This page lists the known errors on the gm5x5x5 PCBs.

Prototype Run

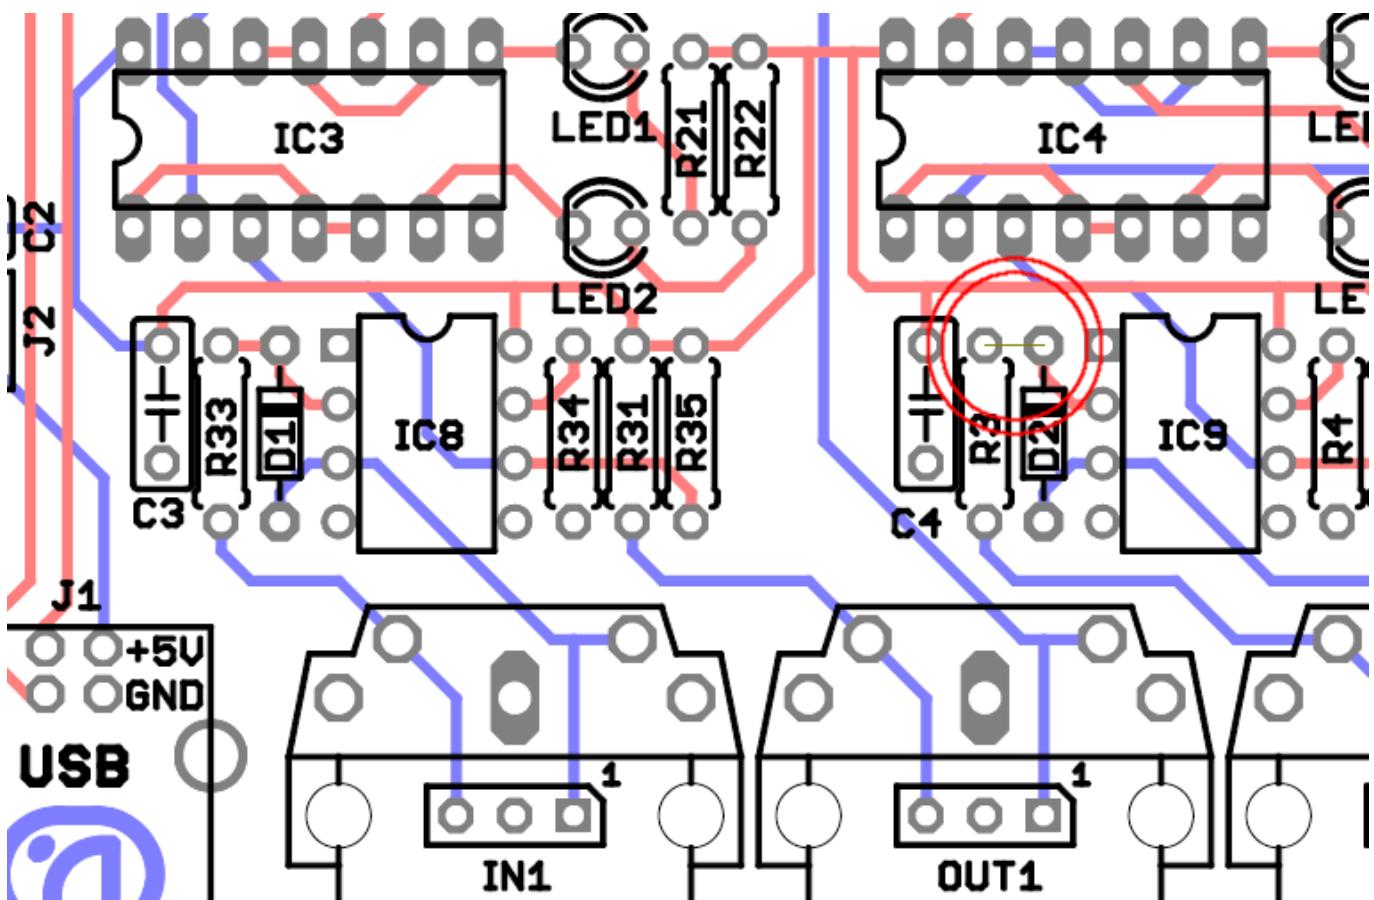
#1 MIDI IO pins

Problem: The MIDI IO pins of the midi sockets (Pin 4 + 5) are switched.

#2 MISSING TRACK

Problem: A track between D2 and R3 is missing.

Solution: Either (1) use the pin-headers if you use sockets that are not mounted on the PCB or (2) break the traces to pins 4 + 5 of the sockets and solder wires to them or (3) solder the midi sockets on the other side of the PCB.

Solution: Bridge the pins.
